## JOINT REGIONAL PLANNING PANEL (Sydney East Region)

<b>JRPP No</b>	<b>2014SYE136</b>
<b>DA Number</b>	<b>DA-505/2014</b>
<b>Local Government Area</b>	<b>City of Canterbury</b>
<b>Proposed Development</b>	<b>Demolition of existing structures and construction of a six storey mixed use development containing ten commercial tenancies and 100 residential apartments over a three (3) level basement carpark</b>
<b>Street Address</b>	<b>364-374 Canterbury Road, Canterbury</b>
<b>Applicant / Owner</b>	<b>Porters Lane Pty Ltd / Maria and Alkis Kadi</b>
<b>Number of Submissions</b>	<b>Two submissions objecting to the proposal</b>
<b>Recommendation</b>	<b>Approval with Conditions</b>
<b>Report by</b>	<b>Rita Nakhle - Senior Planner</b>

### Assessment Report and Recommendation

Section A-A

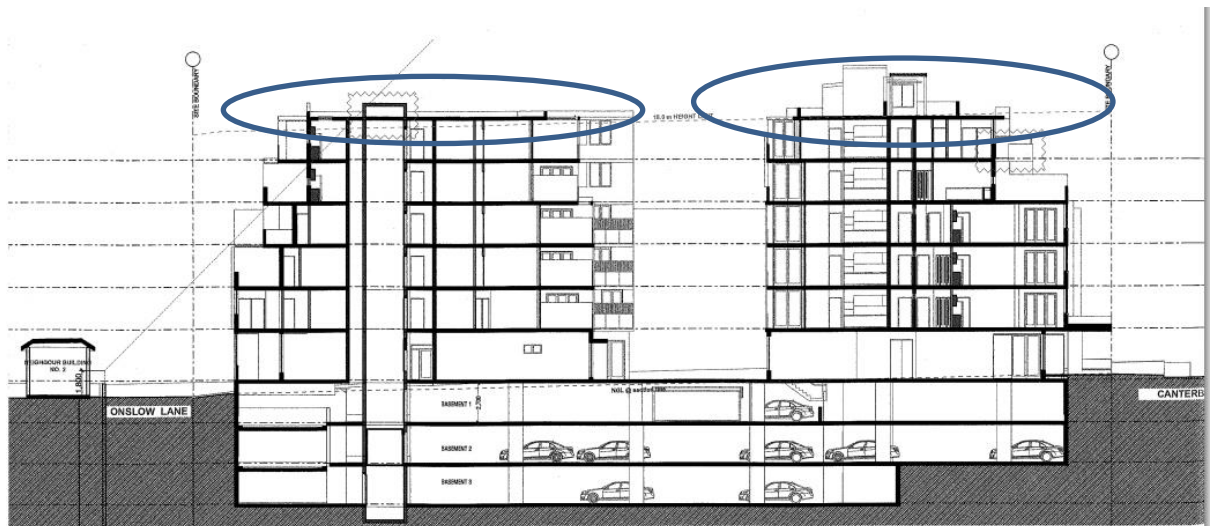
The applicant states that the standard is unnecessary in this instance as the excess height of the proposal relates to a small portion of the building, namely the lift and fire stair overrun, which are necessary to provide access to the communal open space provided on the roof top and a small portion of the roof form. Due to the central location and adequate setbacks of these features, this portion of the building cannot be readily seen from the public domain. The portion of the proposed building that is easily read from the surrounding streets is compliant with the height standard and presents as a well articulated and visually interesting four storey building.

The diagrams below show sections through the proposed development to demonstrate the minor nature of the variation sought.

Having regard to the above commentary, it is considered appropriate in this instance to support the submission under Clause 4.6 of LEP 2012 to permit the proposed development.
